4.032 MHz
Y4
32.768KHz
BT1
3V
K1
4N33 U21
LM324
CR1 IN746
CR2 IN4005
CR3 IN746
CR4 IN746
CR5 IN4005
CR6 HSCH-1001
CR7 IN4148
R9 VARISTOR
PARTS LIST
QTY REQD | PART OR IDENTIFYING NO. | NOMENCLATURE OR DESCRIPTION | MFR. CODE | CIRCUIT REF. | ITEM NO.
UNLESS OTHERWISE SPECIFIED
DIMENSIONS ARE IN INCHES
TOLERANCES ON DECIMALS ± .010 FRACTIONS ± 1/32 ANGLES ± 0° 30'
MATERIAL
CONTR. NO.
DRAWN RJ 1-2-83
CHECK
APPR RWJ 4-5-83
RELEASE DATE 4-20-83 SP
Board Rev B (81-184)
NEXT ASSY. | FINAL ASSY. | NEXT ASSY. | FINAL ASSY.
APPLICATION | QTY.
NOTES: 1 SHIELDED BY 2 ADJACENT GROUNDED TRACES.
NLS NOVEAR SYSTEMS, INC. DEL MAR, CALIFORNIA
SCHEMATIC MODEM & RTC
KAYPRO 4/84
SIZE C | CODE IDENT NO. 03626 | 81-185
SCALE | WEIGHT | SHEET 2F

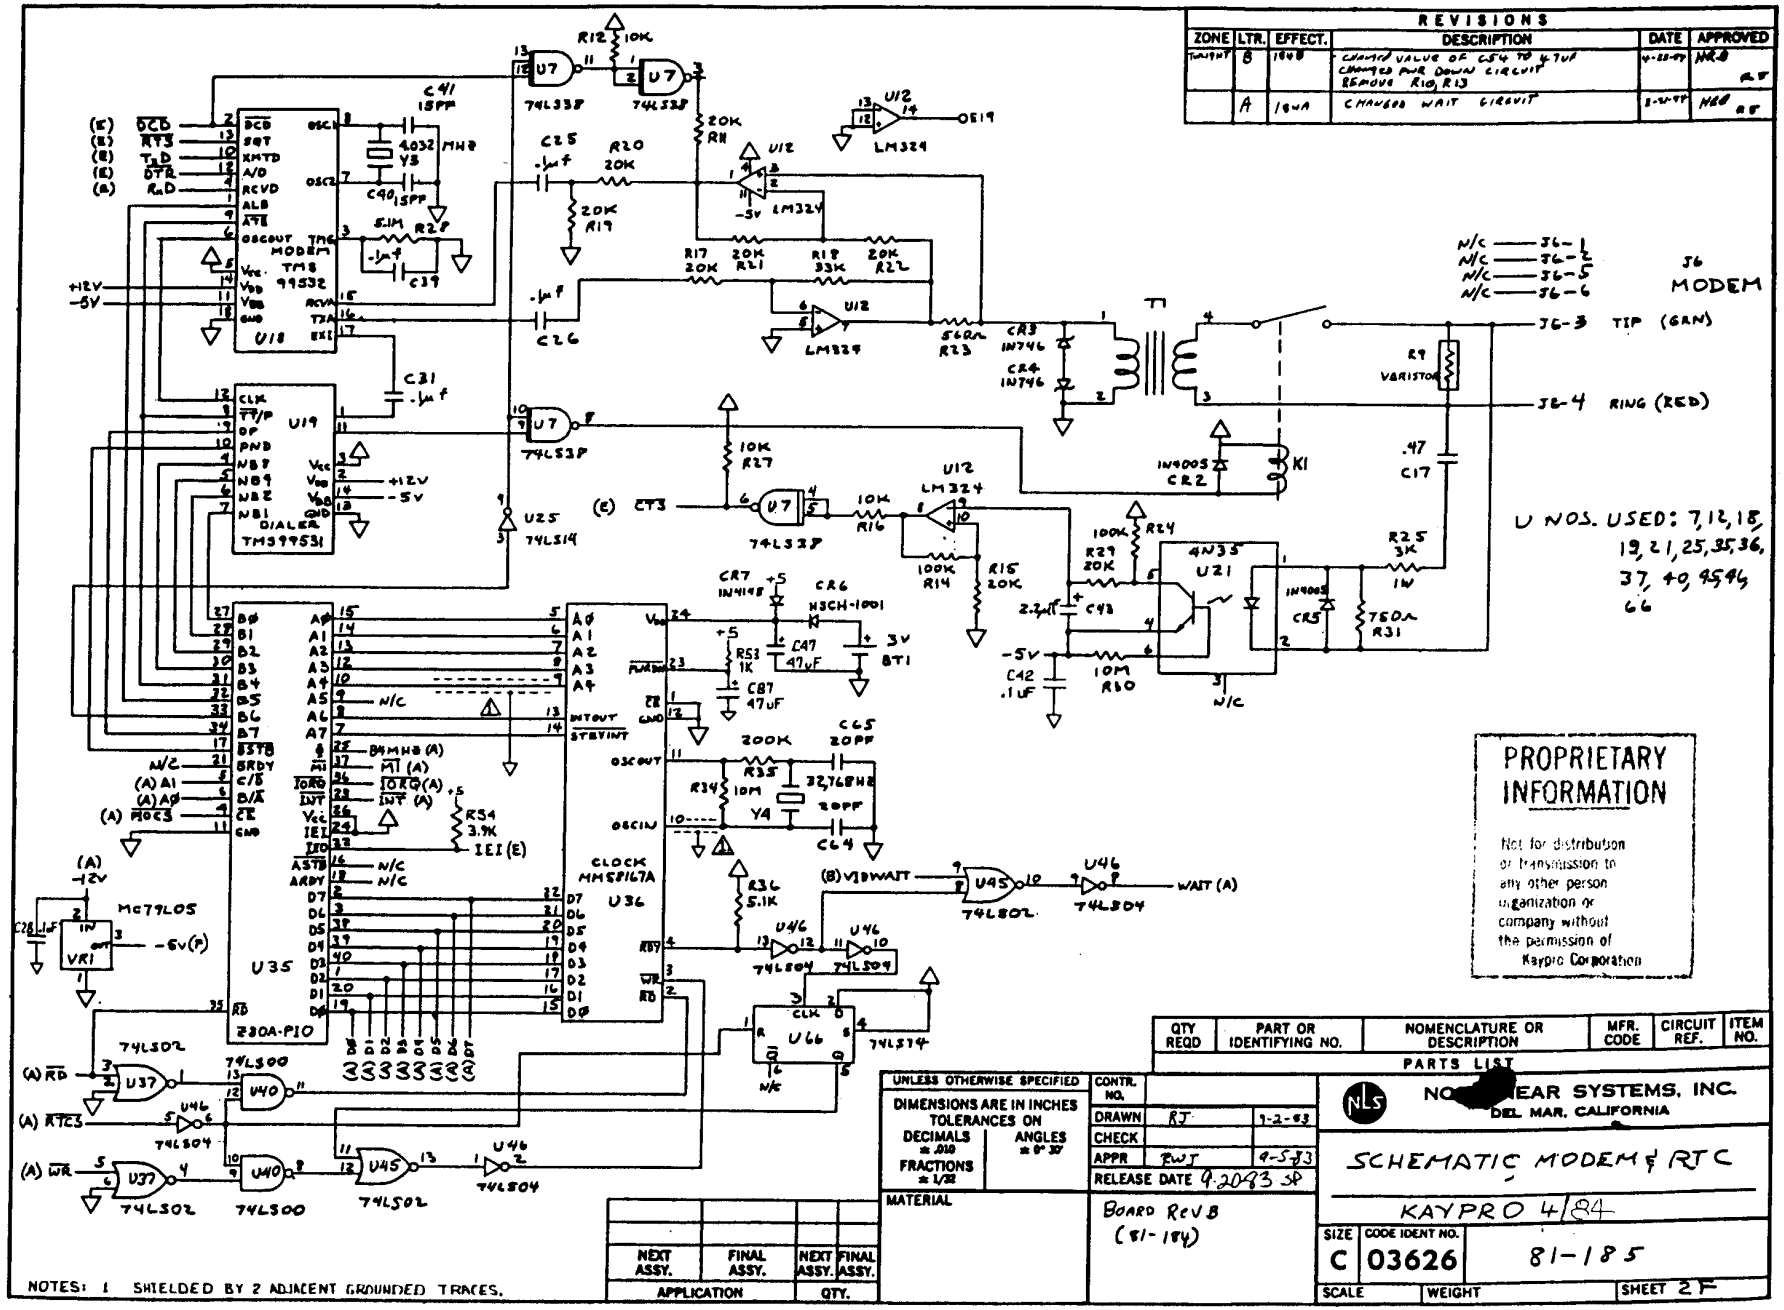
REVISIONS
ZONE | LTR. | EFFECT. | DESCRIPTION | DATE | APPROVED
TWENTY | B | 1648 | CHANGED VALUE OF C54 TO 4.7uF CHANGED PWR DOWN CIRCUIT REMOVE R10, R13 | 4-22-83 | MRB
A | 1644 | CHANGED WAIT CIRCUIT | 2-1-84 | MRB
J6 MODEM
N/C — J6-1
N/C — J6-2
N/C — J6-5
N/C — J6-6
J6-3 TIP (GRN)
J6-4 RING (RED)
U NOS. USED: 7, 12, 18, 19, 21, 25, 35, 36, 37, 40, 45, 46, 66
PROPRIETARY INFORMATION
Not for distribution or transmission to any other person organization or company without the permission of Kaypro Corporation
U35
Z80A-PIO
U36
CLOCK MM58167A
U18
MODEM TMS 99532
U19
DIALER TMS99531
U37
74LS02
U40
74LS00
U45
74LS02
U46
74LS04
U66
74LS74
U49
74LS02
U7
74LS38
U25
74LS14
VR1
MC79L05
-6V(P)
Y3
